Access Compliance Report

Public Rights-of-Way

Intersection ID: 48900	Main Street: PENNACOOK_DR	Cross Street: NATICK_DR	Location: NW
ADA ID: DC7BB394AE7A	Ramp Type: PerpDiag	Initial Pass/Fail: Fail	Overall Compliance: No
Codes/Mitigation Info/Possible Solution		Field Measurements/Component Compliance

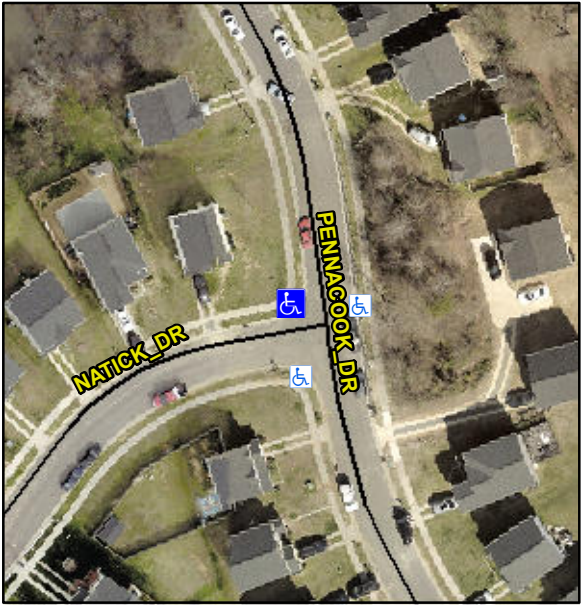
Possible Solutions:		Compliance	Description	Data	Compliance	Description	Data
	Remove & Replace Curb Ramp With Two New Directional Ramps or Equivalent.		N/A	Ramp Length (in)	53.5	Yes	Ramp Slope (%)	5.2
<p>Surveyor Notes:</p> <p>N/A</p> <p>PROW/ADA:</p> <p>Not Found, R304.5.1, R304.5.3</p>			No	Ramp Width (in)	34.5	No	Ramp XSlope (%)	4.1
			N/A	Flare Type LT	N/A	N/A	Flare Type RT	N/A
			N/A	Flare Slope LT (%)	N/A	N/A	Flare Slope RT (%)	N/A
			N/A	Flare Traversable LT?	N/A	N/A	Flare Traversable RT?	N/A
			N/A	Landing Length (in)	N/A	N/A	DWS Provided?	N/A
			N/A	Landing Width (in)	N/A	N/A	DWS Contrast?	N/A
			N/A	Landing Slope (%)	N/A	N/A	DWS Length (in)	N/A
			N/A	Landing X Slope (%)	N/A	N/A	DWS Full Width?	N/A
			N/A	Landing Curb? (Y/N)	N/A	N/A	DWS Offset (in)	N/A
			N/A	Shared Landing?	N/A			
			N/A	Gutter Ponding?	N/A	N/A	Gutter Slope (%)	N/A
			N/A	Gutter Lip Ht (in)	N/A	N/A	Gutter X Slope (%)	N/A
			N/A	Painted X Walk1?	No	N/A	Painted X Walk2?	No

X Walk 1 Direction	To S		X Walk 2 Direction	To E
			N/A	X Walk 1 Width (in)	N/A	N/A	X Walk 2 Width (in)	N/A
				X Walk 1 Slope (%)	3.3		X Walk 2 Slope (%)	0.7
				X Walk 1 X Slope (%)	0.4		X Walk 2 X Slope (%)	0.3
			N/A	Ramp inside XWalk1?	N/A	N/A	Ramp inside XWalk2?	N/A
				Road Slope (%)	3.1	N/A	Clear Space?	N/A
				Road X Slope (%)	3.2	N/A	Clear Space to XWalk (in)	N/A
			N/A	Any Obstructions?	N/A	N/A	Storm Grate/Utility Hazard?	N/A
				Obstruction Type			Storm Grate/Utility Type	
						N/A		N/A
						Yes	Surface Condition? (G/P)	Good
